Product Change Notification

Change Notification #: 113189 - 00
Change Title: Intel® Server System R1208GL4DS
PCN 113189-00, Product Design
Update the Rear Panel and eUSB SSD
stand-off
Date of Publication: August 01, 2014

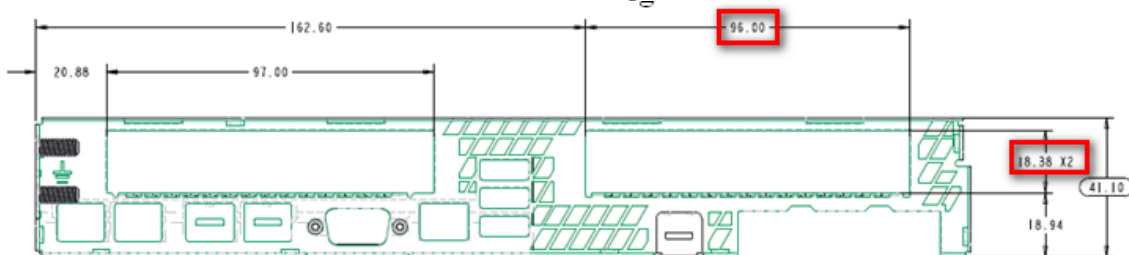
1. Update the system rear panel so that more PCIe devices and cable connectors can mechanically fit into the system. Please refer to the following pictures for details:

Pre-change:

Post-change:
